TENNESSEE VALLEY AUTHORITY

BELLEFONTE NUCLEAR PLANT (BLN) - RESPONSE TO GENERIC LETTER NO. 86-05,
IMPLEMENTATION OF TMI ACTION ITEM II.K.3.5, "AUTOMATIC TRIP OF REACTOR COOLANT
PUMPS"

Bellefonte Nuclear Plant
Response to Generic Letter 86-05 Request for Additional Information
on TMI Action Item II.K.3.5
Automatic Trip of Reactor Coolant Pumps (RCPs)

FIGURE 1

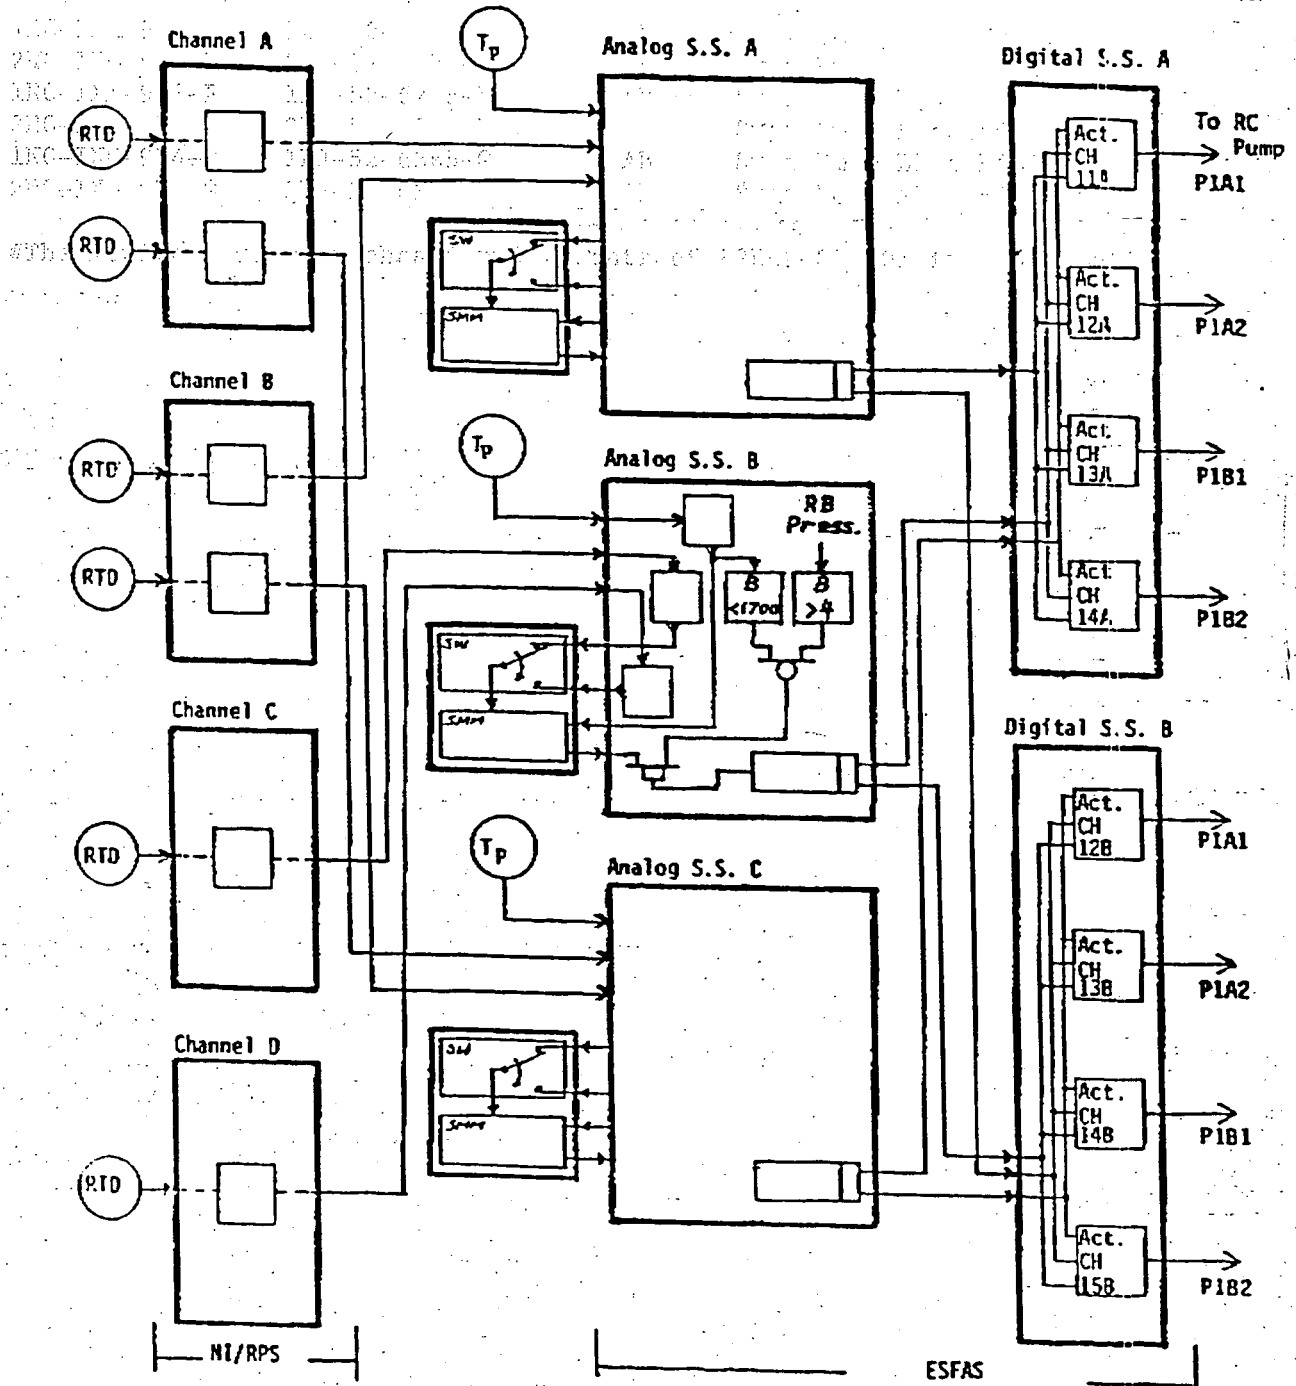
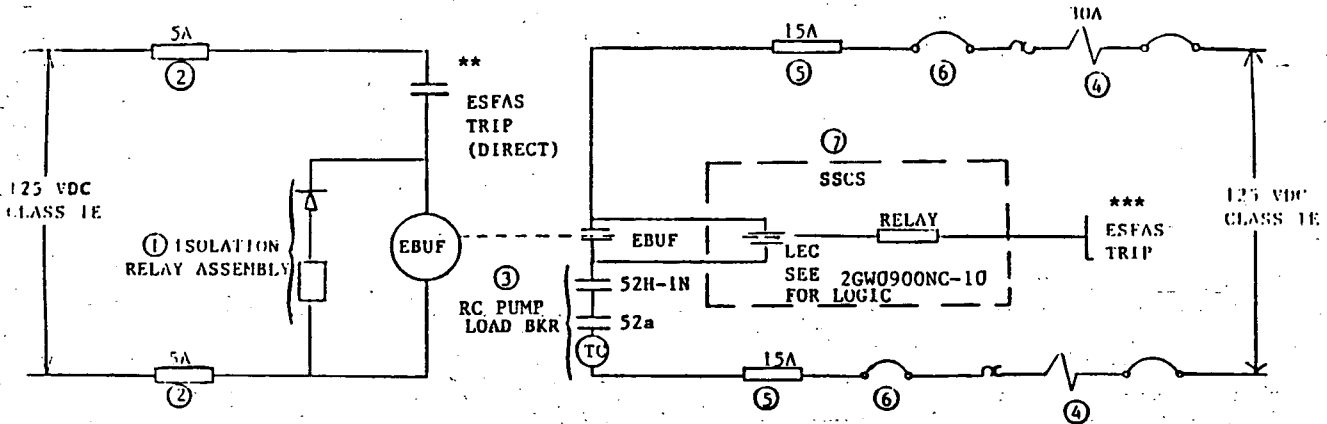
1. Identify the instrumentation to be used to determine the RCP trip setpoint, including the degree of redundancy of each parameter signal needed for the criterion chosen.
2. Identify the instrumentation uncertainties for both normal and adverse containment conditions. Describe the basis for the selection of the adverse containment parameters. Address, as appropriate, local conditions such as fluid jets or pipe whip which might influence the instrumentation reliability.
3. In addressing the selection of the criterion, consideration of uncertainties associated with the BWO or plant specific supplied analyses values must be provided. These uncertainties include both uncertainties in the computer program results and uncertainties resulting from plant specific features not representative of the BWO generic data group.

Figure 1 illustrates the interconnection of the three redundant analog signal processing subsystems and the two redundant actuation subsystems required to perform the RCP trip. Three redundant measurements of Loop A Hot Leg Temperature (Th-A), Loop B Hot Leg Temperature (Th-B), RCS pressure, and RB pressure are used, one in each analog subsystem. The degree of redundancy is the same as for Engineered Safety Features Actuation System (ESFAS) High Pressure Injection (HPI) and Low Pressure Injection (LPI) trip functions. The single failure criterion of IEEE-279 is met.

Figure 2

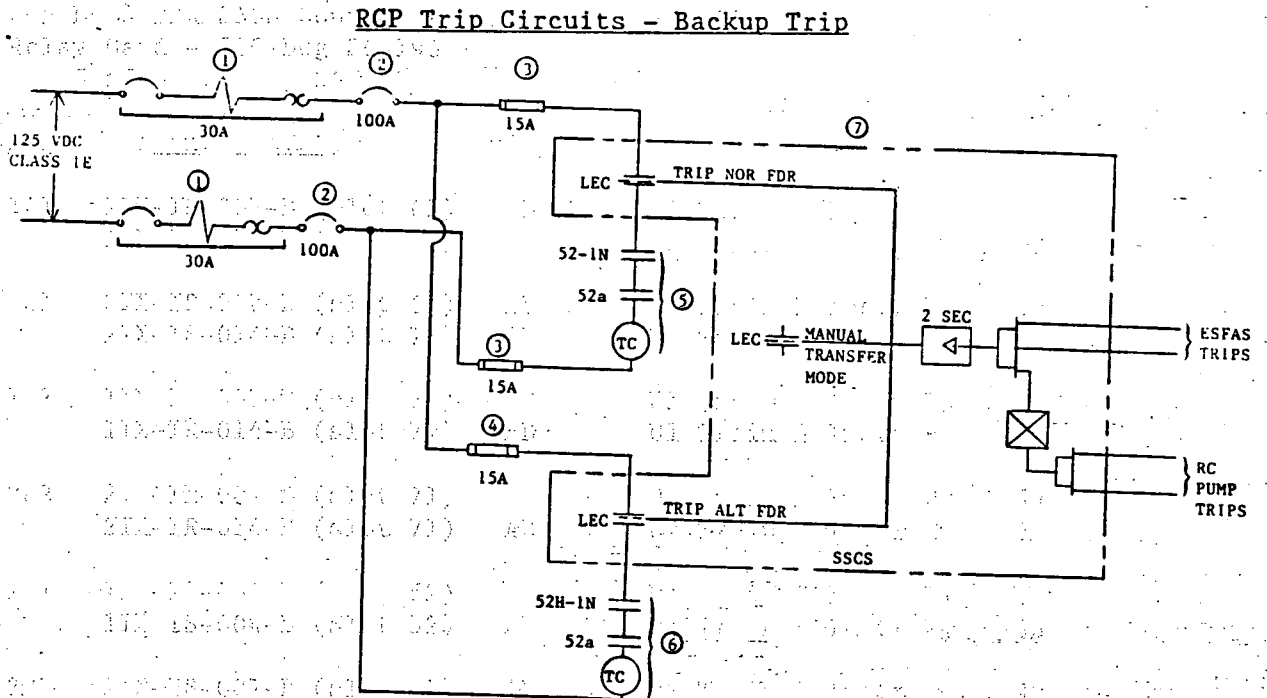
1. Assure that containment isolation, including inadvertent isolation, will not cause problems if it occurs for non-LOCA transients and accidents.
 - a. Demonstrate that if water services needed for RCP operations are terminated, then they can be restored fast enough to prevent seal damage or failure once a non-LOCA situation is confirmed.
 - b. Confirm that containment isolation with continued pump operation will not lead to seal or pump damage or failure.
2. Identify the components required to trip the RCPs, including relays, power supplies and breakers. Assure that RCP trip, when determined to be necessary, will occur. If necessary, as a result of the location of any critical component, include the effects of adverse containment conditions on RCP trip reliability. Describe the basis for the adverse containment parameters selected.

The RCP trip circuits, shown in Figure 2, receive trip signals from both ESFAS digital subsystems. In the event that any one pump is not properly tripped, a backup trip signal from the Solid State Control System (SSCS) will occur with both the normal and alternate switchgear feeds being tripped with manual transfer being selected. The RCP backup trip circuits are shown on Figure 3.
